**Convertible Top Mechanism Replacement: Rework Required Before Installation (40/22)**

Model Line: **Boxster (986)**

Concerns: **Convertible top mechanism**

*Convertible top mechanism*

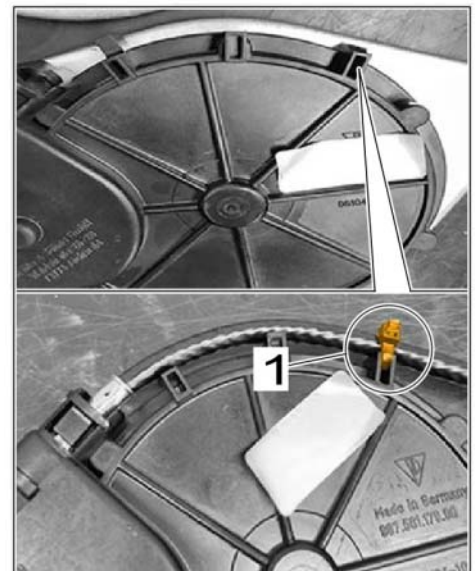
Information: The remaining convertible top inventory (Part Nos.: 98756117901 or 98756118001) may contain convertible top mechanisms without guide pegs for the drive shaft.

Action required: Before installing a new convertible top mechanism, secure the drive shaft to the convertible top mechanism with a tie-wrap if necessary.

- 1 Use a tie-wrap to secure the drive shaft ⇒ *Convertible top mechanism -1-* to the bore of the convertible top mechanism.

The bore on the convertible top mechanism has already been drilled by the supplier.
